**AGENDA**  
**Planning and Zoning Commission**  
**April 17, 2024 – REGULAR MEETING**  
**5:30 PM**

| <b>Meeting Date:</b>          | April 17, 2024                                                                                                                                                                                                      | <b>Meeting Title:</b>  | Planning Commission |
| <b>Agenda Item:</b>           | Planned Unit Development Amendment, Development Plan, and Conditional Use Permit for the Presbyterian Church of Jackson Hole Housing Development at Parcel 1 along South Park Loop Road (P23-206, P23-204, P24-007) | <b>Public Comment:</b> | Yes                 |

| SHEET<br><b>C2.1</b>           |            |

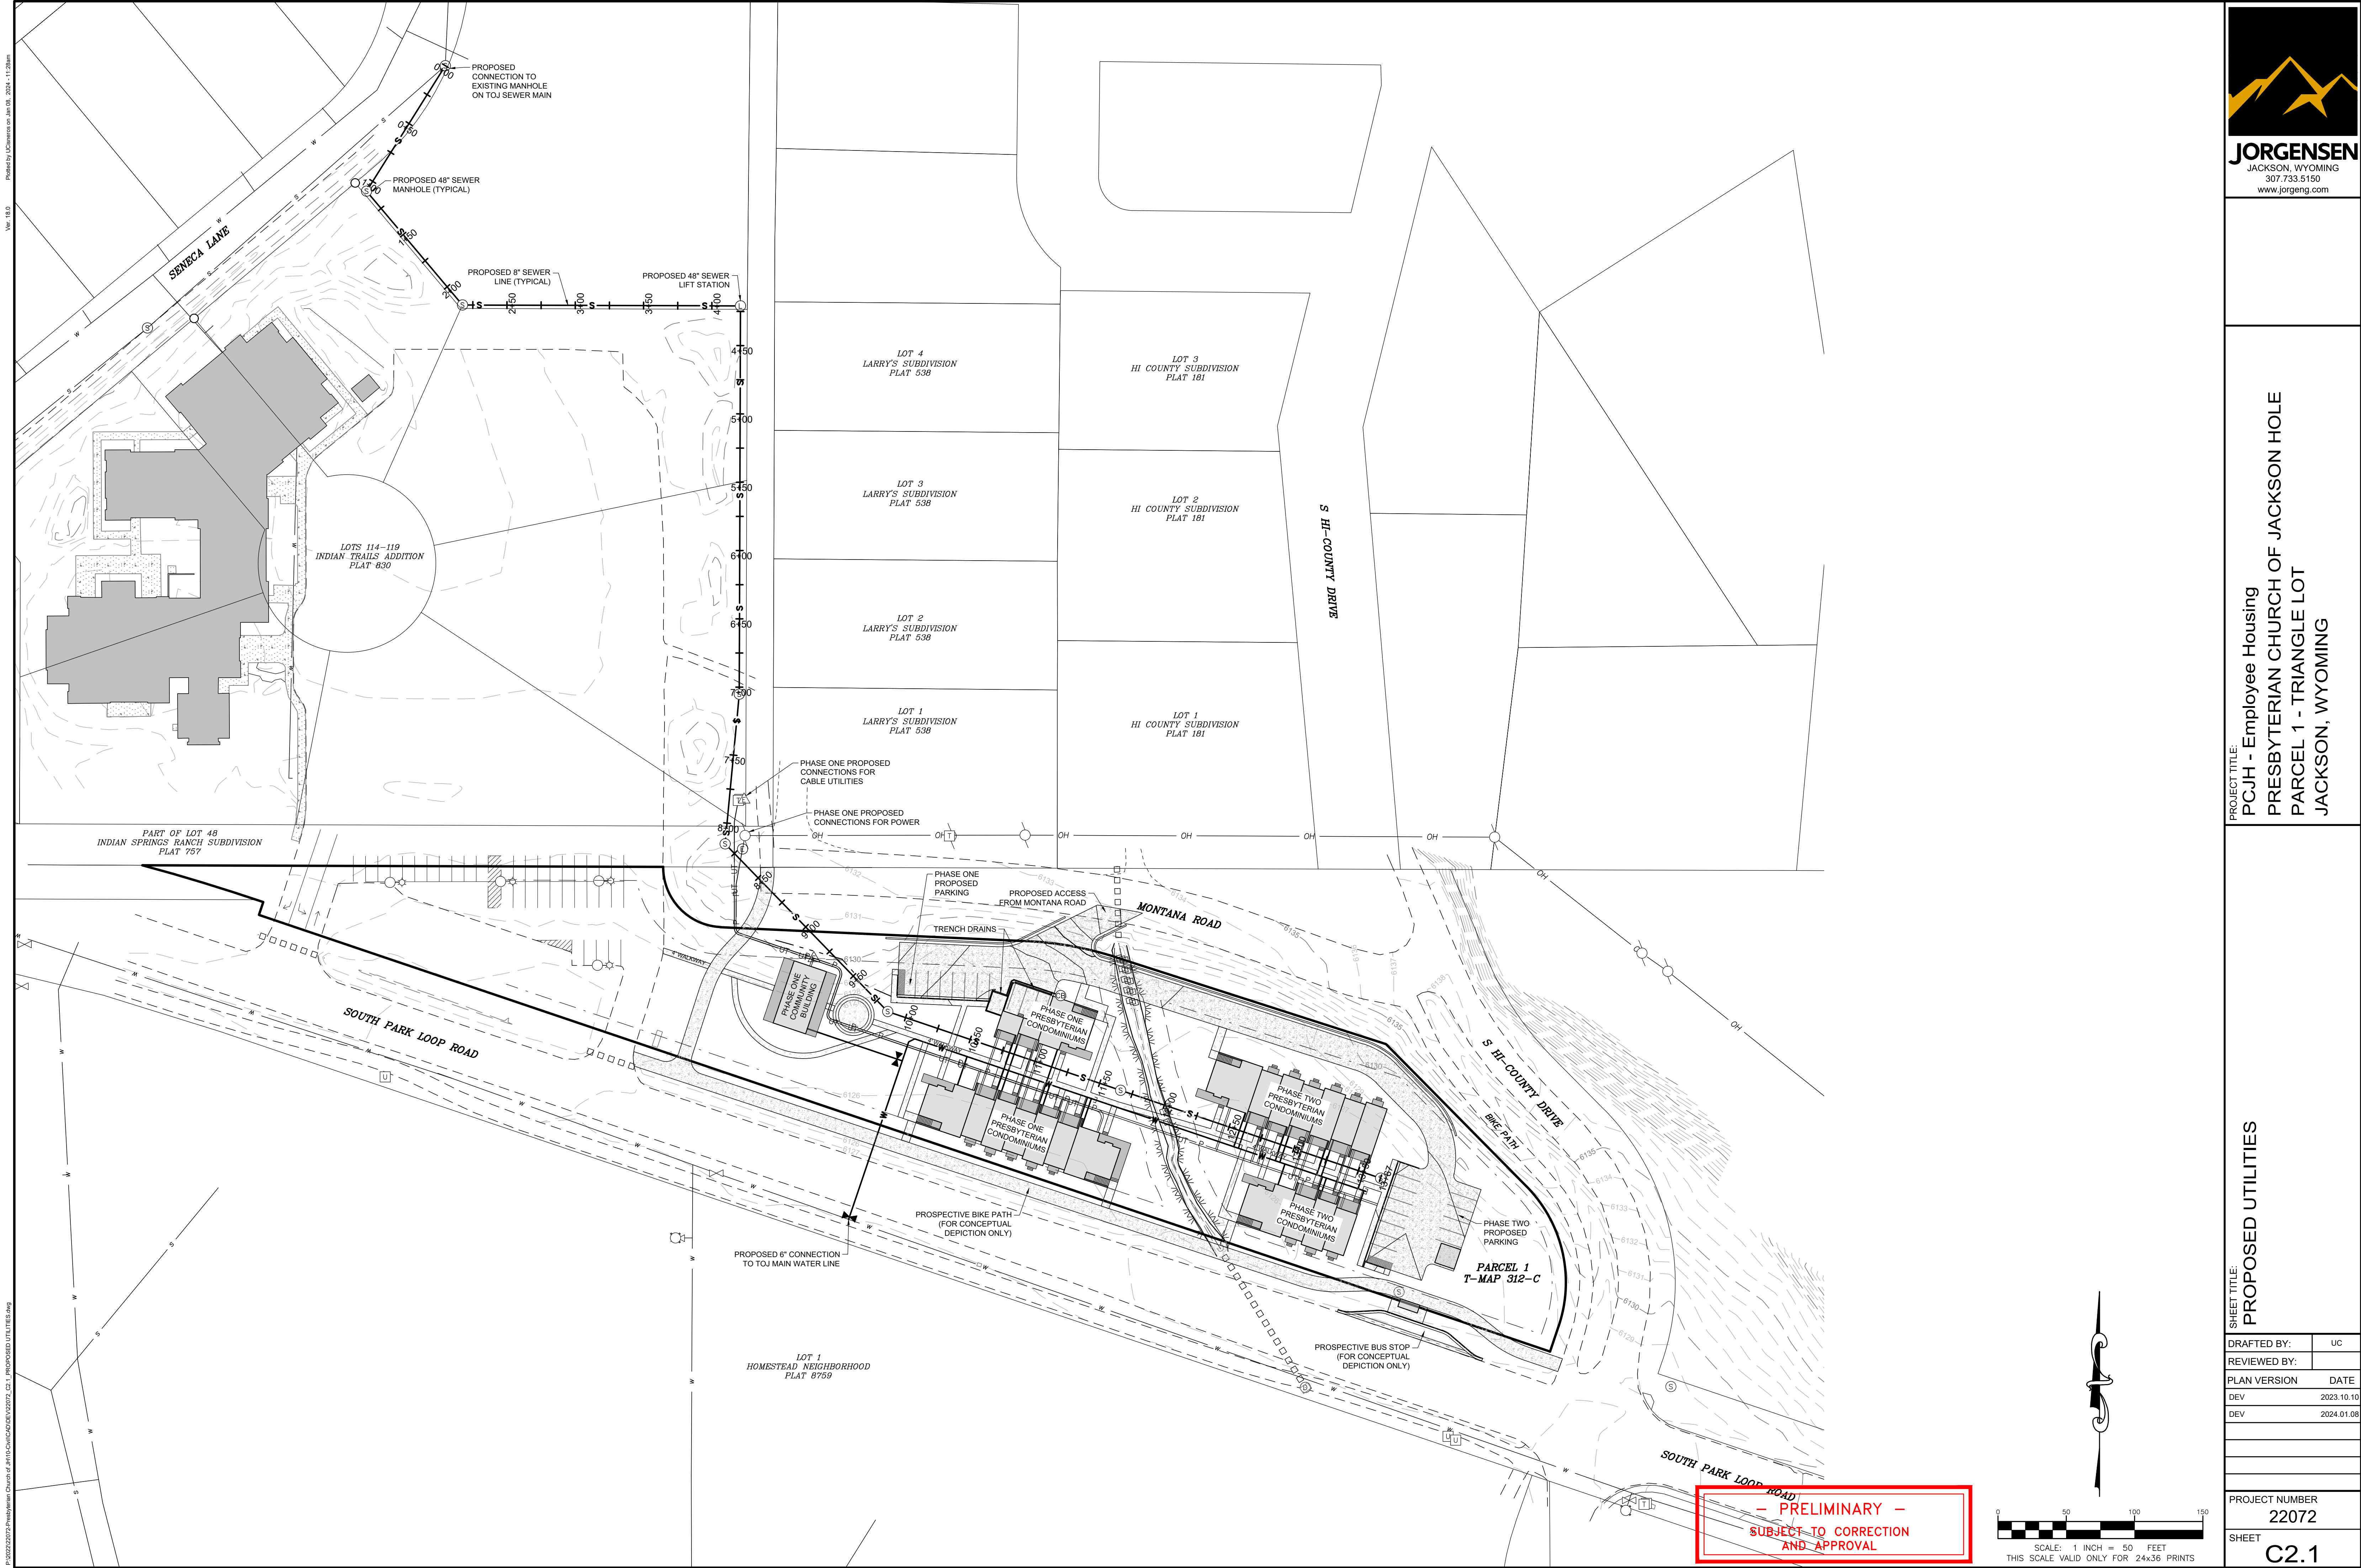
| Permit Number | Begin Date | Step Type                | Text                                                                                                                                                                                                                                                                                                                                                                                                                                                                                                                                                                                                                                                                                                                                                                                                                                                                                                                                                                                                                                                                                                                                                                                                                                                                                                                                                                                                                                                                                                                                                                                                                                                                                                                                                                                                                                                                                                                                                                                                                                                                                                                                                                                                                                                        | Created By | End Date |
|---------------|------------|--------------------------|-------------------------------------------------------------------------------------------------------------------------------------------------------------------------------------------------------------------------------------------------------------------------------------------------------------------------------------------------------------------------------------------------------------------------------------------------------------------------------------------------------------------------------------------------------------------------------------------------------------------------------------------------------------------------------------------------------------------------------------------------------------------------------------------------------------------------------------------------------------------------------------------------------------------------------------------------------------------------------------------------------------------------------------------------------------------------------------------------------------------------------------------------------------------------------------------------------------------------------------------------------------------------------------------------------------------------------------------------------------------------------------------------------------------------------------------------------------------------------------------------------------------------------------------------------------------------------------------------------------------------------------------------------------------------------------------------------------------------------------------------------------------------------------------------------------------------------------------------------------------------------------------------------------------------------------------------------------------------------------------------------------------------------------------------------------------------------------------------------------------------------------------------------------------------------------------------------------------------------------------------------------|------------|----------|
|               |            |                          | 6)Our records show that the sewer line in Seneca Lane flows to the south and the proposed connection is in the up stream direction. Review and revise accordingly.<br>7)Provide a plan for flushing the water main with each phase.<br>8)Provide hydrants for fire protection and water main flushing and maintenance.<br>9)Engineers report states 6 domestic and 6 fire line. A single 6 line shown on plans. Only one tap for the property will be allowed unless hydraulically justified. Review and revise accordingly.<br>10)The intersection with Montana road should be perpendicular to Montana. Westbound interior radius is tight. Slopes and having a max grade of 5% approaching the road should be reviewed; or as approved by the county access permit. Provide a note that the stormwater infiltration requires WYDEQ 5D2 permit.<br>Sheet C3.0<br>11)Remove detail X/CX.X for 1.5 and 2 inch water services. This detail is out of date and should not be used as galvanized pipe is not allowed. Clarify which services are this size. Review and Revise accordingly.<br>12)Fire Service Entry Detail: This does not match the Engineers report. Residential units with compliant 13D residential systems (water filled, not fire department connections) do not require separate domestic and fire entries. Review and revise.<br>13)Service Connection Thaw Wire Detail: No galvanized pipe allowed. Thaw wire may be used on copper pipe. Review and revise.<br>14)For valves within the right of way, no Concrete Collar for water valve lids. Use HMA or UPM cold mix note.<br>Sheet C3.2<br>15)Town is revising the standard for manholes to eliminate steps in order to reduce the potential for unauthorized entry. Standard Manhole Detail: Eliminate built in steps.<br>16)Manhole Collar: Eliminate concrete collar and use a hot mix collar.<br>Sheet C3.3<br>17)Sanitary Sewer Service and Building Cleanout Detail: Check compatibility of SCH40 PVC services with ASTM D3034/D312 specs for rubber gasketed bell and spigot from testing tee to elbows.<br>18)Confirm if storm pipe will be SCH40 PVC and sanitary pipe will be SDR 35.<br>Sheet A-02<br>19)Fellowship cabin requires grease mitigation on the sewer line. |            |          |
